## IDAP REPORT

<b>Property:</b>	20 Firth Avenue Strathfield Lot 112 in DP 8778 DA2021.118
<b>Proposal:</b>	Demolition of existing structures and construction of a two (2) storey dwelling house with basement level, swimming pool, secondary dwelling, landscaping works and front fencing.
<b>Applicant:</b>	M Cubed Architects
<b>Owner:</b>	X Shao and Z Ke
<b>Date of lodgement:</b>	26 May 2021
<b>Notification period:</b>	1 to 15 June 2021
<b>Submissions received:</b>	<b>Nil</b>
<b>Assessment officer:</b>	M Rivera
<b>Estimated cost of works:</b>	\$1,503,000.00
<b>Zoning:</b>	R2 – Low Density Residential - SLEP 2012
<b>Heritage:</b>	No
<b>Flood affected:</b>	No
<b>Is a Clause 4.6 Variation Proposed:</b>	No
<b>RECOMMENDATION OF OFFICER:</b>	<b>APPROVAL</b>

**Figure 14.** Proposed front fence

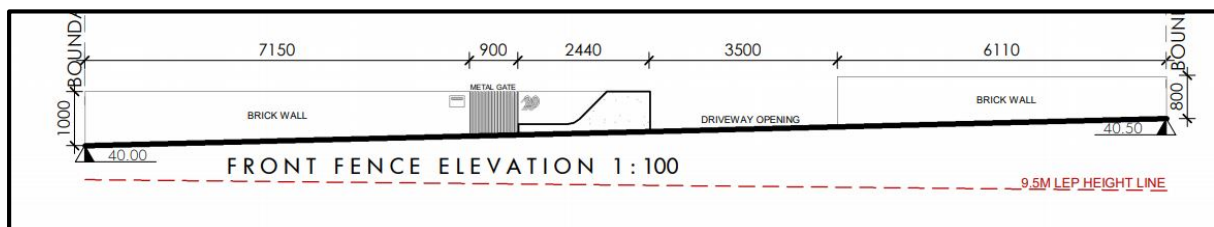
The design of the proposed front fencing, which comprises 0.8-1m tall, masonry piers and walls, demonstrates general compliance with the relevant controls for front fencing (refer to Figure 14). It is noted however, that the solid portion of the fence exceeds the maximum 0.7m control under the DCP. The proposed variation to this control is considered acceptable and reasonable given that the entire fence does not incorporate any additional elements such as metal screening or palisades and is entirely open. Further, the fence does not detract from the existing fencing commonly occurring within the vicinity and will complement the new dwelling house.
